## Product Change Notice (PCN)

**Subject:** Change in Marking Format on Select Device

**Publication Date:** 3/6/2023

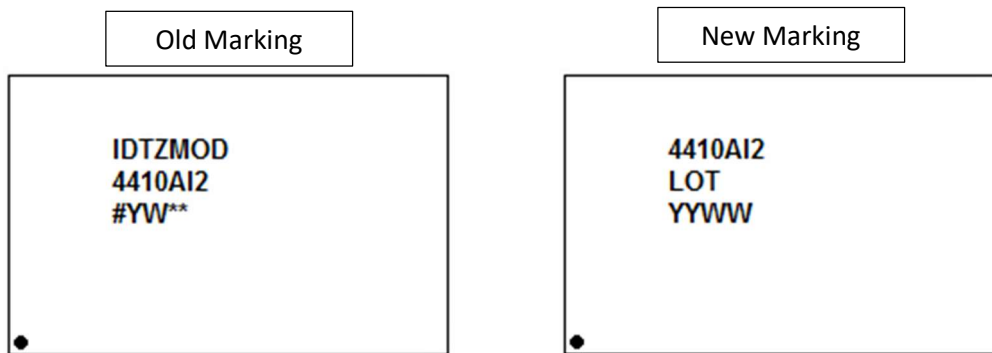
Renesas is changing the marking format on ZMOD4410AI2R and ZMOD4410AI2V to align with the AI1 version of the device as shown in the below diagram.

where Line 1: IDT + Device part number  
 Line 2: Device part number  
 Line 3: # Stepping  
 YW Datecode  
 \*\* Lot sequence

Line 1: Device part number  
 Line 2: Lot number  
 Line 3: YYWW Datecode
